CSB-1054-2
Country : UK
Date : 11/13/2006
APC : ALL
Repair Level : 2

Title V3V3 05 CR - GSM - WDL Location Change
Model Effected V3 & V3_05

BATTERY INSULATOR

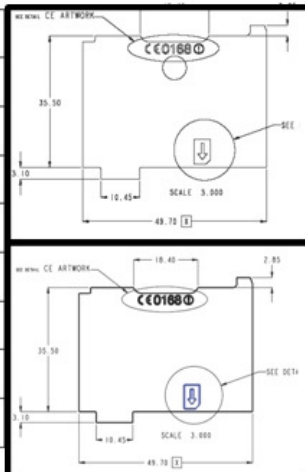
The design change consist of relocating the liquid detect label form the front flip assembly to the rear housing assembly.

Part Number Changes:

PART NUMBER	MATERIAL COLOR	ARTWORK COLOR	WDL HOLE
I487942Y01	WHITE	BLACK	REQUIRED
I487942Y02	WHITE	BLACK	REQUIRED
I487942Y03	BLACK	WHITE	REQUIRED
I487942Y04	BLACK	WHITE	REQUIRED
I487942Y05	WHITE	BLACK	NO HOLE
I487942Y06	WHITE	BLACK	NO HOLE
I487942Y07	BLACK	WHITE	NO HOLE
I487942Y08	BLACK	WHITE	NO HOLE

Repair guidelines for liquid detection label location.

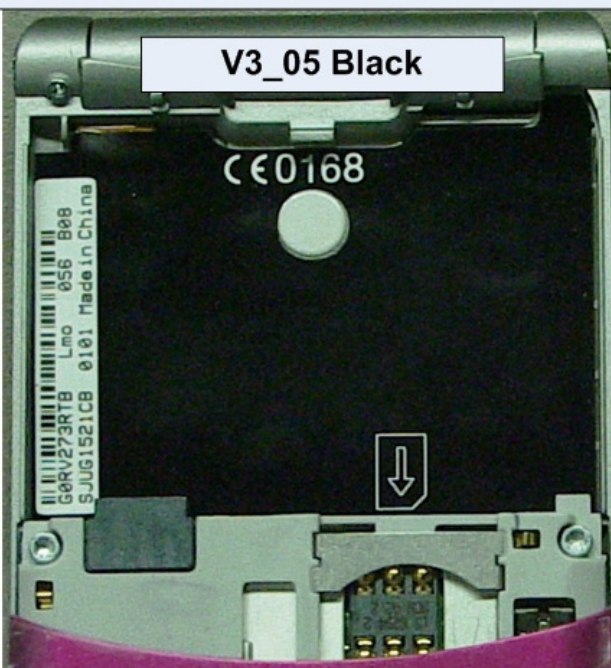
ORIGINAL WDL

Acceptable

NEW WDL

Acceptable

TWO WDL

**Acceptable if
Shortage of Material**

NO WDL

Not Acceptable

When repairing or refurbishing any Razr GSM (V3 & V3_05) that requires replacement of the housing, use the parts with the new liquid detect label location.

Repair guidelines for battery insulator color.

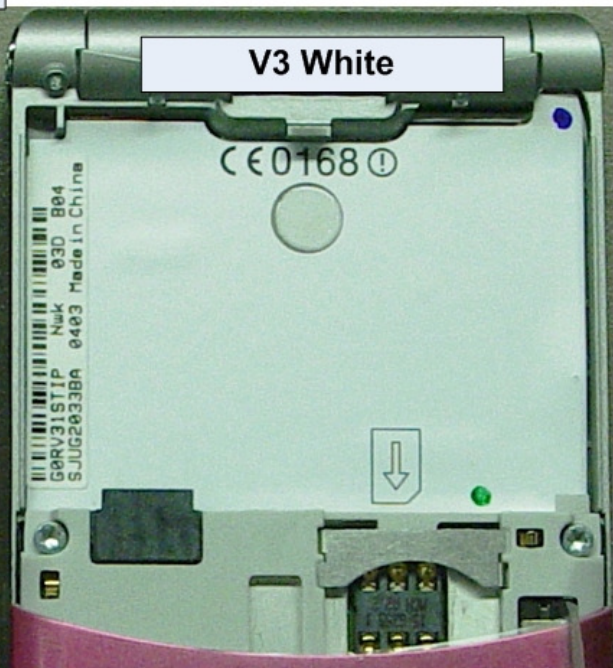
BATTERY INSULATOR COLOR

V3_05 Black

V3 White
